SERVICE BULLETIN

Service Bulletin No. 381C
 (Supersedes Service Bulletin No. 381B)
 Engineering Aspects are
 FAA (DEER) Approved

SUBJECT: Oil Pump Woodruff Key Drive and Impeller Replacement

Figure 1. Interior View of Accessory Housing Showing Location of Cotter Pin in Oil Pump Idler Shaft

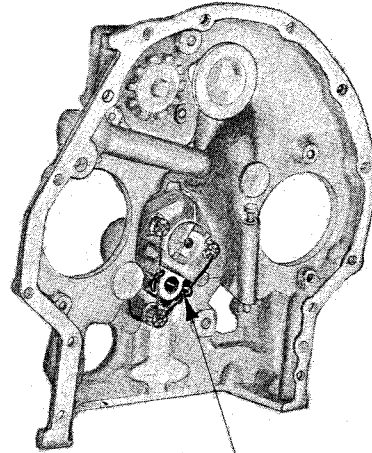
INSPECTION: Applicable remanufactured engines shipped after December 21, 1972 should be inspected to determine if this modification is required: first of all, if the engine log book indicates the engine has not been modified in accordance with Service Instruction No. 1230 or No. 1272, proceed to remove the accessory drive cover from the mounting pad at the lower right side of the accessory housing to obtain access to the area between the crankcase and the accessory housing. On some engines this accessory drive pad is not machined, in this event it will be necessary to remove either the left magneto or the *fuel pump to obtain access to the area between the crankcase and the accessory housing. Regardless of which accessory pad is used, determine if the oil pump idler gear is secured with a cotter pin at the location shown in figure 1. This can be accomplished using an inspection mirror, preferably an illuminated one. If the cotter pin is visible, it is unnecessary to perform the modification required by this bulletin.

IF IDLER SHAFT IS SECURED WITH A COTTER PIN AT THIS LOCATION MODIFICATION IS NOT REQUIRED

Figure 2. Oil Pump Drive Assembly

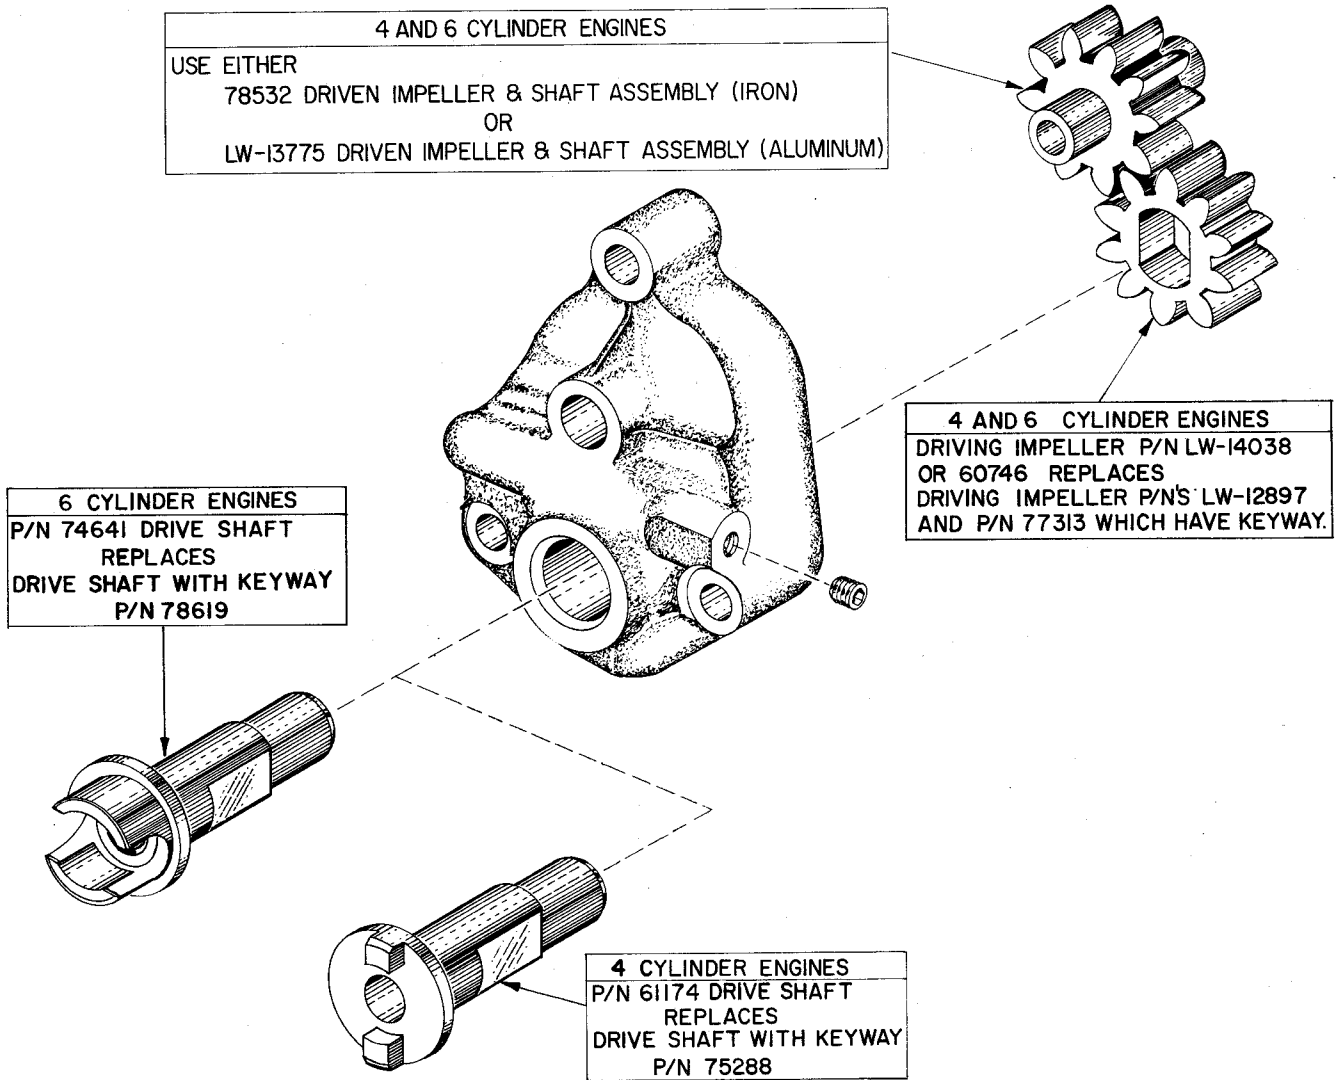
This modification consists of replacing the oil pump drive shaft and drive impeller to eliminate the Woodruff key drive which has proven to be the cause of excessive wear in the keyway of the hardened drive impeller. Therefore, it is recommended that all of the applicable engines installed in aircraft listed above, as well as any others that may have been modified in accordance with Service Instruction No. 1272, use the following procedure for parts replacement.

3. Reassemble the oil pump using the new drive shaft and drive impeller supplied with the kits shown in the following "Parts Data" section. See figure 2. Be sure all of the parts are lubricated thoroughly during assembly. After assembly, turn the drive shaft several revolutions to determine if it moves freely; if not, open the pump and correct the cause before the unit is reassembled on the engine.

- LW-14129 Gasket Kit, Oil Pump Shaft Replacement (4 cylinder engines)
consists of: (1) 60096 fuel pump gasket, (3) 62224 magneto gasket, (1) 73818 accessory housing gasket, (2) LW-12681, -1200 series magneto gasket, (1) LW-13353 oil sump gasket.
- LW-14130 Gasket Kit, Oil Pump Shaft Replacement (6 cylinder engines)
consists of: (1) 60096 fuel pump gasket, (3) 62224 magneto gasket, (1) 73818 accessory housing gasket, (2) LW-12681, -1200 series magneto gasket, (1) LW-14128 oil sump repair gasket.
- LW-14131 Oil Pump Shaft Replacement Kit (4 cylinder engines)
consists of: (1) 61174 oil pump drive shaft, (1) LW-14038 or 60746 drive impeller.
- LW-14133 Oil Pump Shaft Replacement Kit (6 cylinder engines)
consists of: (1) 74641 oil pump drive shaft, (1) LW-14038 or 60746 drive impeller.

Figure 1. Interior View of Accessory Housing Showing Location of Cotter Pin in Oil Pump Idler Shaft

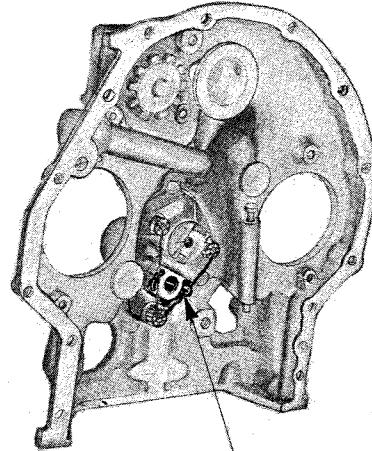
IF IDLER SHAFT IS SECURED WITH A COTTER PIN AT THIS LOCATION MODIFICATION IS NOT REQUIRED
